TSTF-169, Rev. 1

Industry/TSTF Standard Technical Specif	fication Change Traveler
---	--------------------------

**Delete Condition 3.3.1.N**

## Bases Insert B 3.3-45C

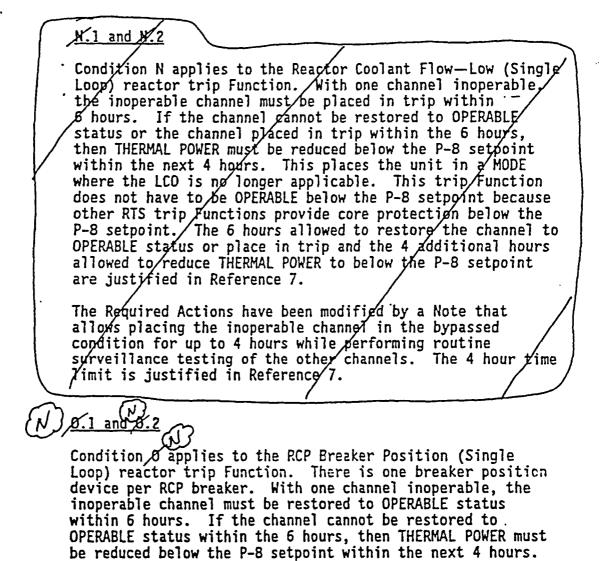
For the latter two trip Functions, two tripped channels in two RCS loops are required to initiate a reactor trip when below the P-8 setpoint and above the P-7 setpoint.

There is insufficient heat production to generate DNB conditions below the P-7 setpoint.
